# SERVICE BULLETIN

SB No. 117 Issue No. 1

**TITLE** INSPECTION OF ELEVATOR ELECTRIC TRIM MOTOR WIRE ROUTING

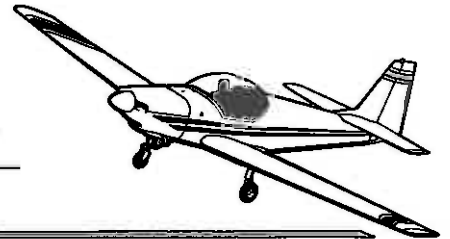
A case has been reported of a foul between the electric trim motor wiring and the centre console, resulting in chafing of the motor wiring.

1. Remove the centre console.
2. Thoroughly inspect the two wires connected to the trim electric motor, looking for any signs of chafing damage, especially where the wires may have come into contact with the centre console cover or the forward edge of the rear console.
3. If the aircraft has logged over 100 flying hours and there are no signs of the onset of scuffing, enclose the two wires adjacent to the trim motor for a distance of approximately 100mm with 2 lengths of 3mm spiral binding, one for each wire.
4. Position and secure the wires in such a way as to avoid contact with the centre and rear consoles when the trim system is operated.

5. If the inspection reveals signs of chafing of the trim motor wiring in the area specified in 2. above, invoke SAL Mod M761.
6. Replace the centre console cover.
7. On completion of this Service Bulletin, annotate in the aircraft log book "SB117 complied with".
